INFORMATION LETTER 206L-99-62

SUBJECT: Alternate Means of Compliance to FAA AD 99-02-01

REFERENCES: FAA AD 99-02-01 Dated January 6, 1999

Figure 1
PL AD 99-02-01

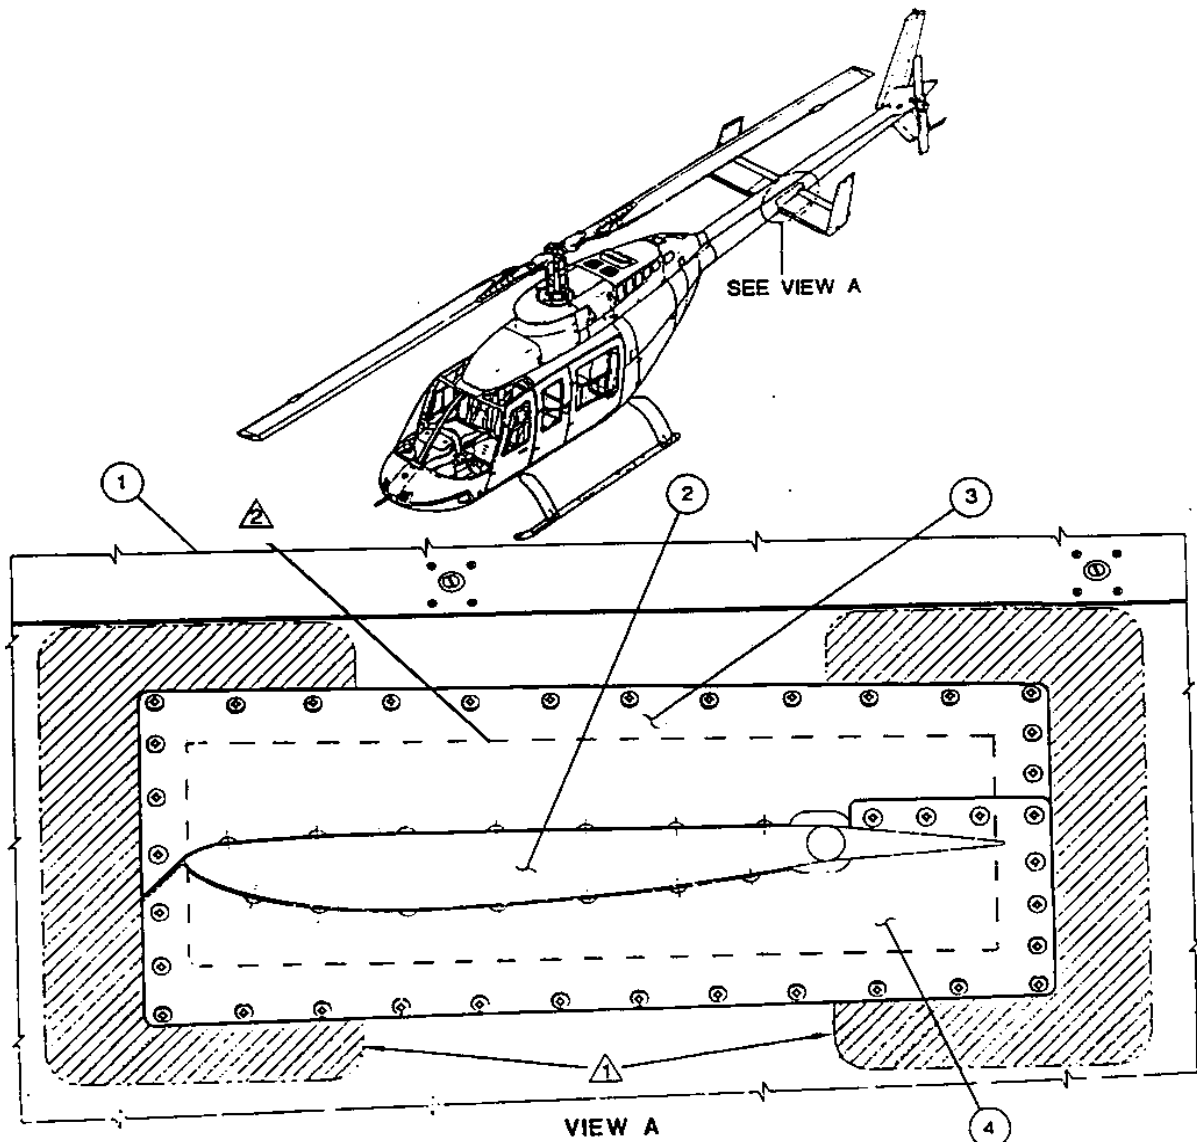
- (a) Before further flight and thereafter, at intervals not to exceed 10 hours time-in-service (TIS), visually inspect for any cracks in the shaded areas shown in figure 1. Use a 10-power or higher magnifying glass. If a crack is found, replace the tailboom with an airworthy tailboom

- (b) At intervals not to exceed 5 hours TIS, visually conduct a preflight check of the shaded areas shown in figure 1 for any cracks. If a crack is found, replace the tailboom with an airworthy tailboom. The visual check may be performed by the owner/operator (pilot) holding at least a private pilot certificate, and must enter into the aircraft records showing compliance with this inspection.

- (c) Within 50 hours TIS:
 - (1) Remove all 4 horizontal stabilizer supports, P/N 206-023-100-all dash numbers, from the tailboom and the horizontal stabilizer.
 - (2) Perform a one-time fluorescent-penetrant inspection of the edges of the tailboom skins for any cracks around the left and right horizontal stabilizer openings (Figure 1). Remove paint and primer to inspect the edges and exterior skin surface in the skin area at least 3/4 inch around the edges of the horizontal stabilizer openings.
 - (3) If crack is found, replace the tailboom with an airworthy tailboom.
 - (4) After completion of the one-time FPI, the inspection with the use of a 10-power or higher magnifying glass, as referenced by (a) above, is not required. However (b) above is still required.

- (d) After completion of (c) above, at intervals not to exceed 100 hours TIS conduct the following:
 - (1) Remove all 4 horizontal stabilizer supports, P/N 206-023-100-all dash numbers, from the tailboom and horizontal stabilizer.
 - (2) Visually inspect with a 10-power or higher magnifying glass for any cracks on the entire edge of the horizontal stabilizer opening on both sides of the tailboom.
 - (3) If a crack is found, replace the tailboom with an airworthy tailboom.
